Fashion 2000 Ltd.

03 October 2013

Building Observations

Two Storey Cantilever

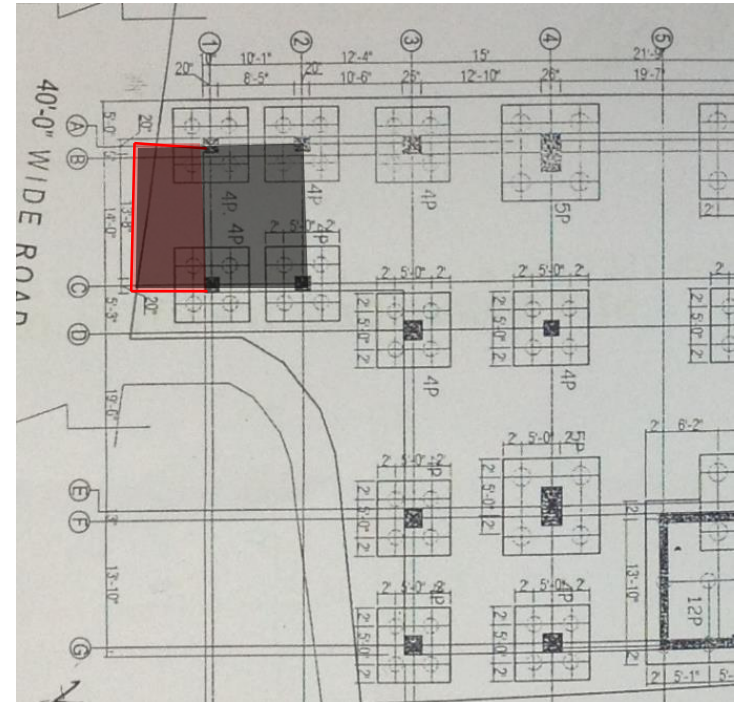
**Two storey cantilever area at front of
building not shown on drawings**

Cantilever slab is not shown on drawings

Structure of 2nd floor cantilever could not be determined because of stored material

Structure of 1st floor cantilever could not be determined because of false ceiling and floor finishes in place (office space)

**Building Engineer to confirm by calculations that column and cantilever slab are designed adequately.
If necessary, reduce loads (loading plans to be prepared)**

Two Storey Cantilever

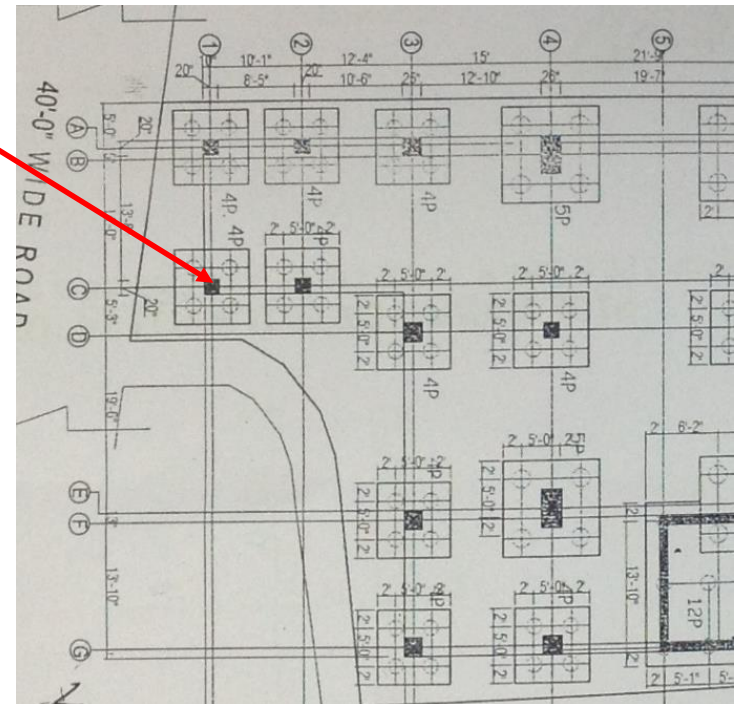
It is unclear if the slab alone is supporting the cantilever, or if there are beams in place

Storage loading on 2nd floor cantilever

Roof Slab - Water causing damage to building fabric and potential for reinforcement corrosion

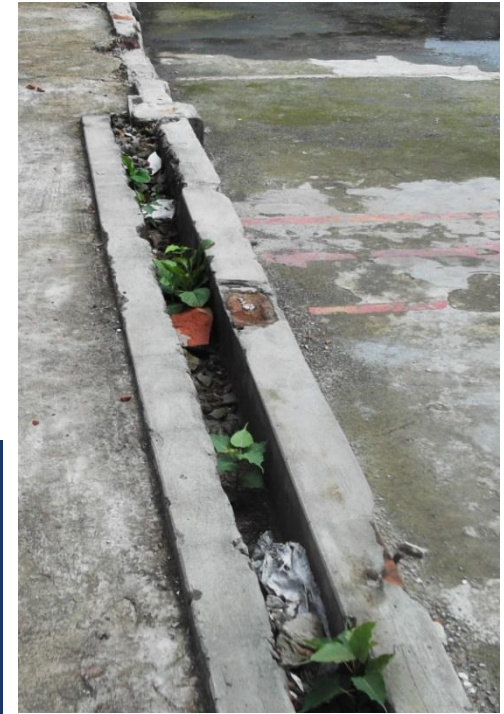
Removal of previous roof structure resulted in damage to concrete slab. Roof drainage is not effective.

Water causing deterioration of building fabric

**Unmanaged roof
drainage and roof surface
causing deterioration of
building fabric**
